Product Change Notification

Change Notification #: 113627 - 00
Change Title: Intel® Server System P4304BTL SFCNR
PCN 113627-00, Product Design,
Add two latches and labels for the fixed HDD
(Hard Disk Drive) Tray
Date of Publication: February 9, 2015

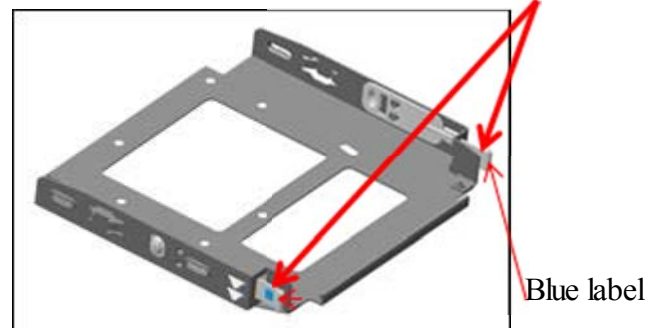
Add two latches and labels for the fixed HDD (Hard Disk Drive) tray to enhance the robustness of the HDD tray and indicate the touch point for the HDD tray assembly.
